EMLA-2022-BF103-02-001

Subject: Submittal of the Drilling Work Plan for Chromium Groundwater Project
Regional Aquifer Monitoring Well R-77, Revision 1, and Comment Response

**Drilling Work Plan for Chromium Groundwater Project
Regional Aquifer Monitoring Well R-77, Revision 1**

**U.S. Department of Energy Responses to New Mexico Environment Department
Draft Comments on “Drilling Work Plan for Chromium Groundwater Project
Regional Aquifer Monitoring Well R-77”
Dated April 2022**

Figure 1 Proposed location for R-77

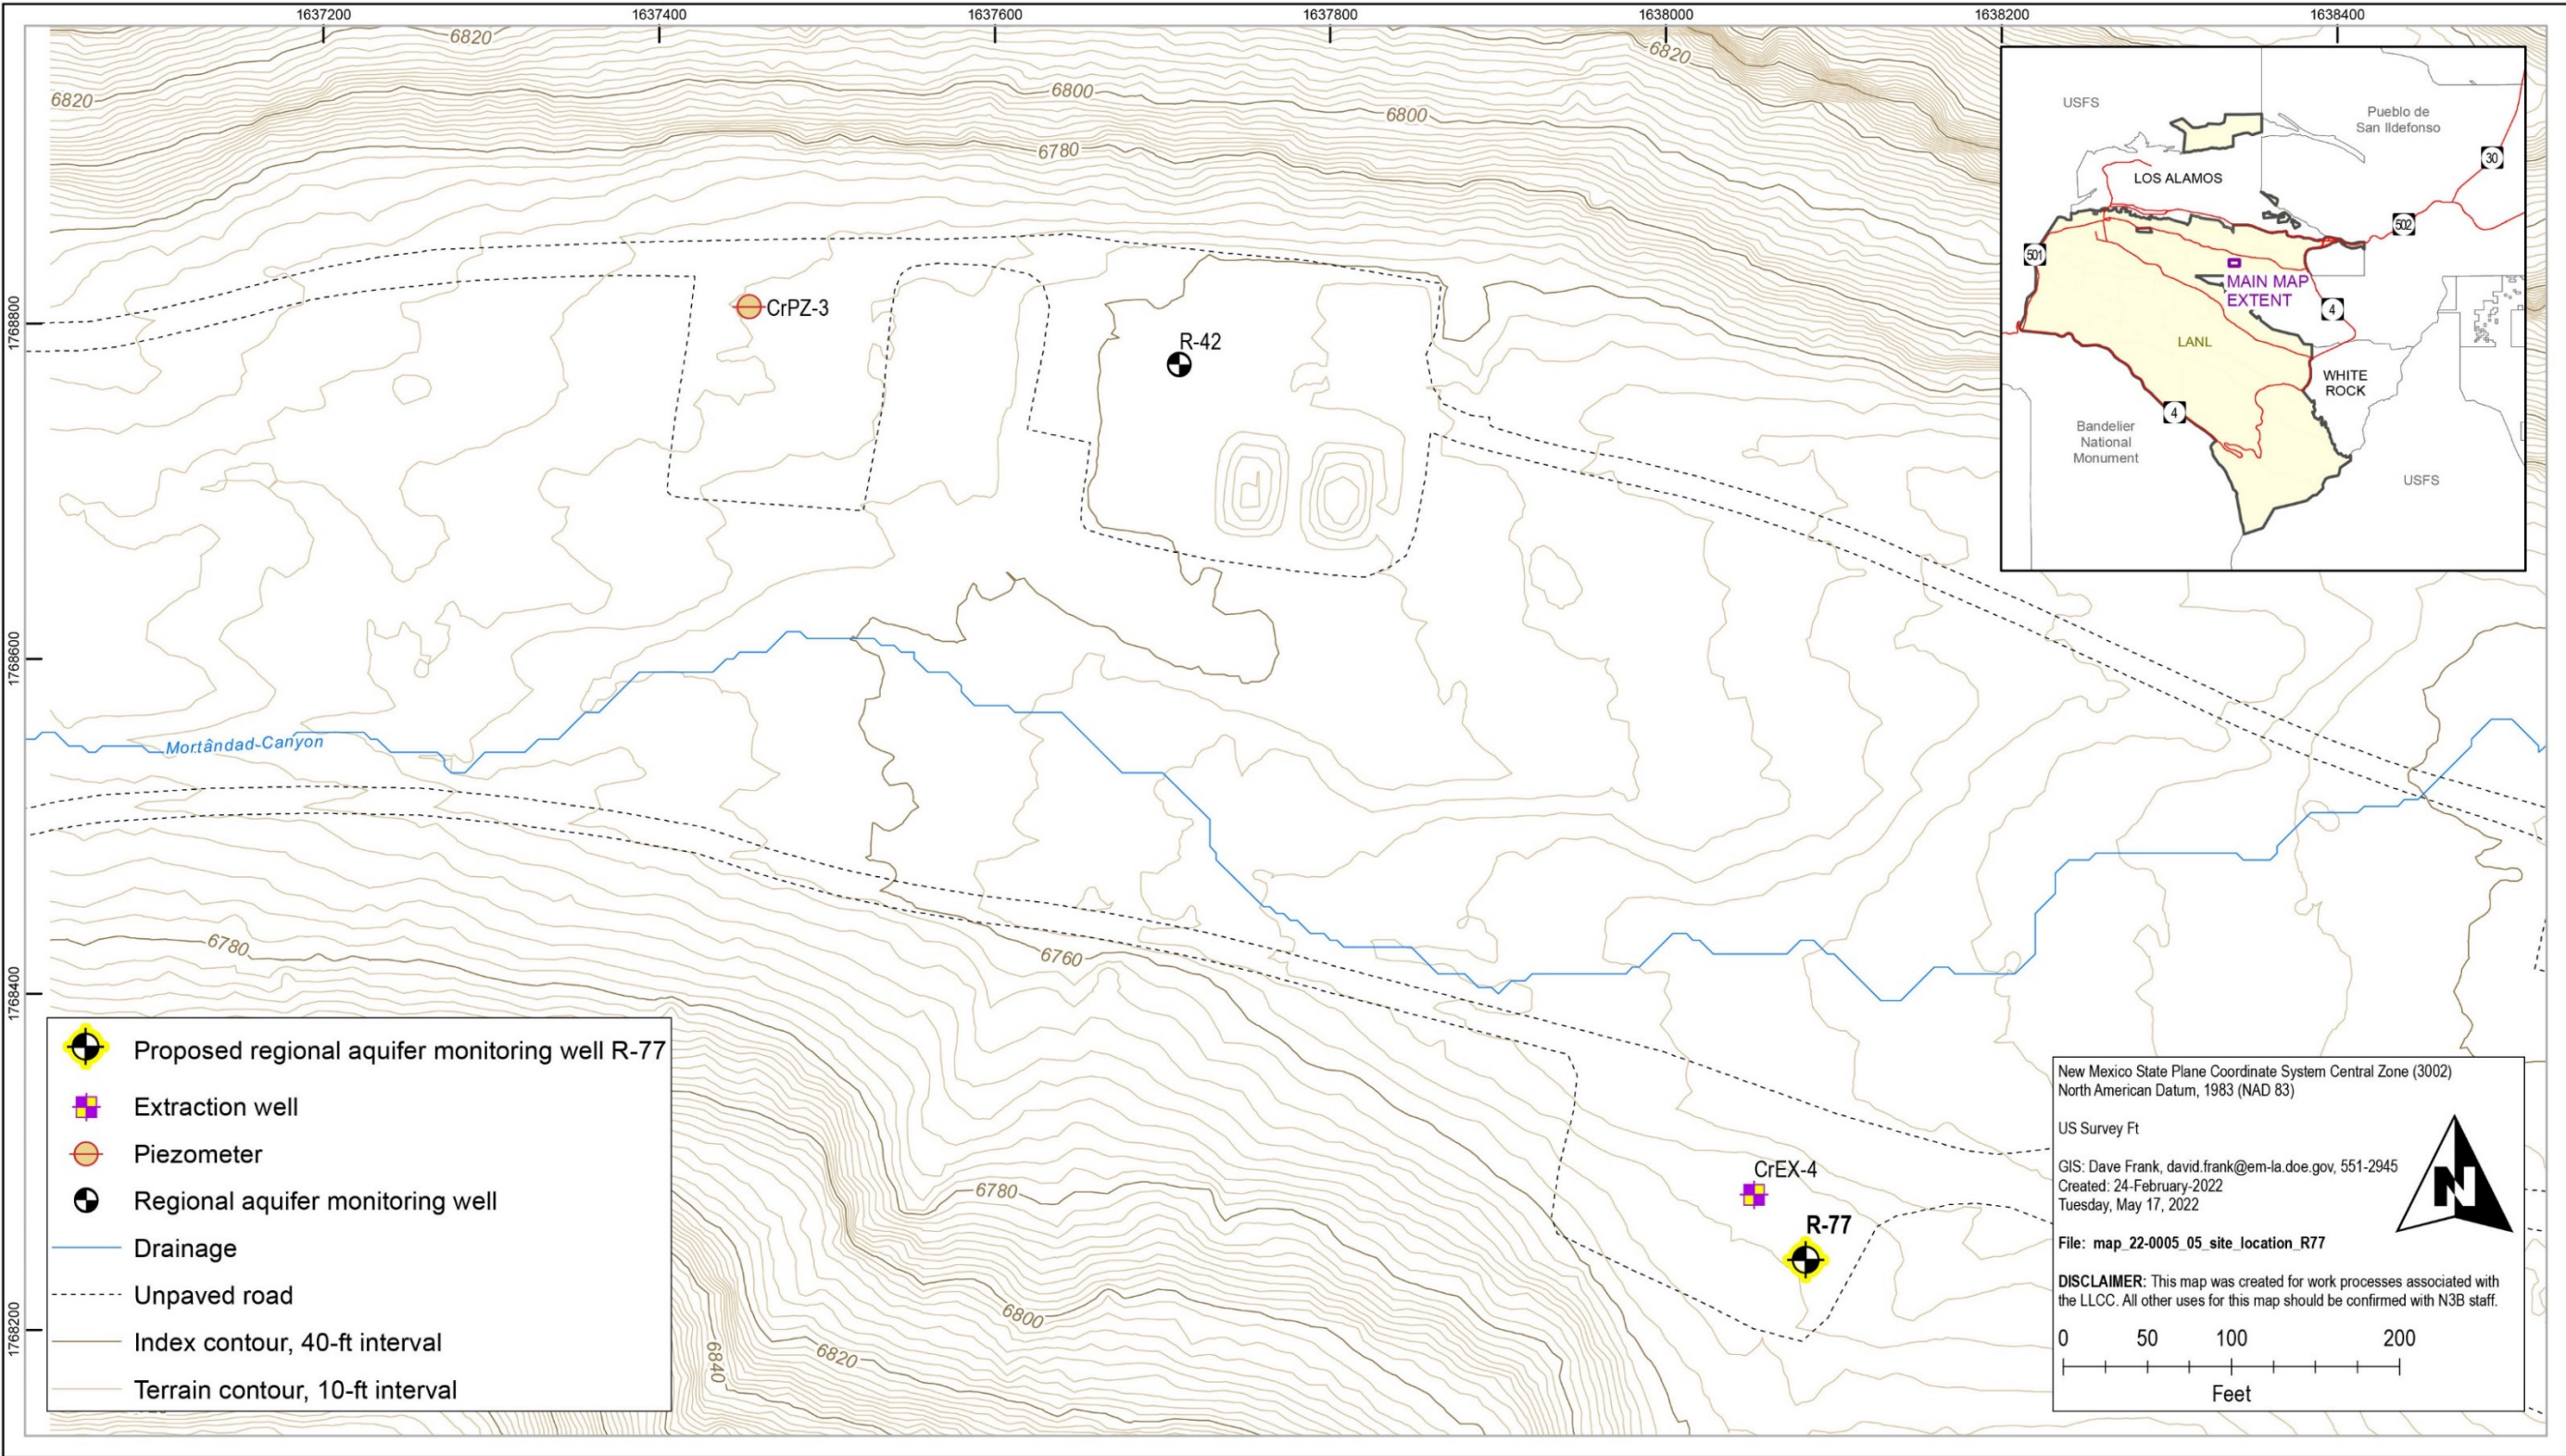
NMED Comment: *DOE’s proposed drilling location for monitoring well R-77 as shown in Figure 1 on page 5 (see NMED specific comment nos. 8 and 9) appears about 250 feet southeast of R-42 and about 375 feet northwest of CrEX-4. This location is not off-gradient from the potential effects of the sodium dithionite deployed at R-42 in 2017 because the associated injection would have created a temporary hydraulic high at R-42 that would have forced the sodium dithionite out of the well and into the regional aquifer in all directions, specifically downgradient (southeast) toward CrEX-4. Consequently, the area between R-42 and CrEX-4 may likely be affected by potential reductive conditions from the deployment as operation of CrEX-4 would pull the amendment and oxidation products, iron, manganese, and other injectates (sodium carbonate-sodium bicarbonate) from R-42 southeast and down to CrEX-4. To avoid effects of the sodium dithionite and other natural and injected chemicals deployed at R-42, DOE must relocate R-77 southeast and downgradient of, and as adjacent as possible to, CrEX-4. Additionally, because the primary objective for R-77 is to characterize vertical extent of chromium contamination in the regional aquifer near CrEX-4, which has a total depth 20 feet above the top of the Chamita Formation (Tcar), NMED’s suggested location with its greater proximity to CrEX-4 will provide the best data and information to determine the vertical extent of chromium contamination and fulfil the primary objective for R-77. In the revised Workplan, DOE must relocate the proposed location accordingly in all pertinent sections and figures of the revision.*

8. *Figure 1, Proposed location for R-77, Page 5.*

NMED Comment: *Revise Figure 1 to show the proposed location for R-77 to be immediately southeast of CrEX-4. See Specific Comment No. 1c.*

1. c. While DOE developed its proposed location with the goal of avoiding drilling into the zone previously impacted by dithionite deployed in R-42, DOE agrees to modify the well location per this comment. The drilling work plan has been revised accordingly.

8. The figure has been revised.

Figure 2 Cross-section showing the stratigraphy and screen positions for nearby wells and the proposed location and well-screen positions for R-77

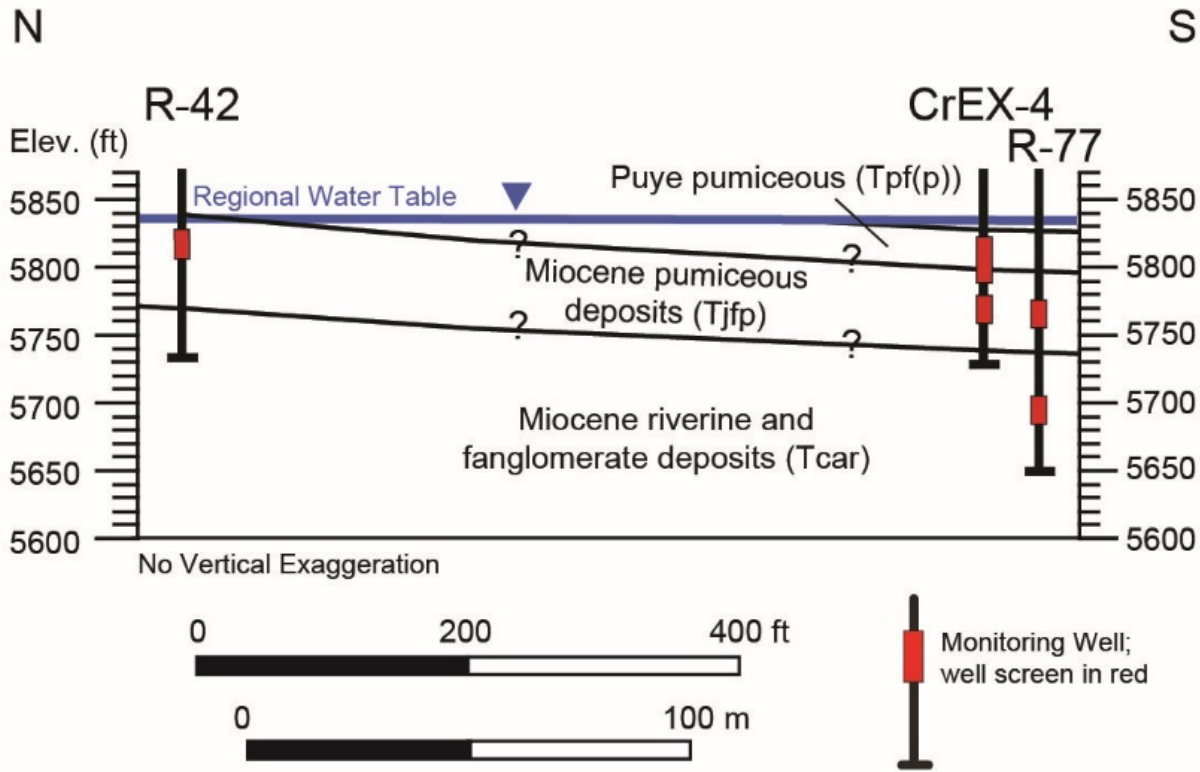
9. **Figure 2, Cross-section showing the stratigraphy and screen positions for nearby wells and the proposed location and well-screen positions for R-77, Page 7.**

NMED Comment: *Revise the Workplan to show R-77 in cross-section east of CrEX-4 (See NMED specific comments nos. 1c and 8). The target screen interval for R-77 S1 should be between about 5,760 and 5,780 feet and R-77 S2 to be about 5,700 and 5,720 feet MSL. Vertical spacing of well screens should be about 50 feet and the top of the screens are not within 20 feet of a major hydrogeological contact.*

9. Figures 2 and 3 have been revised to reflect the change in the proposed well location and the initial conceptual design of the well. The final well design package will present a proposed design based on data collected during and subsequent to drilling.
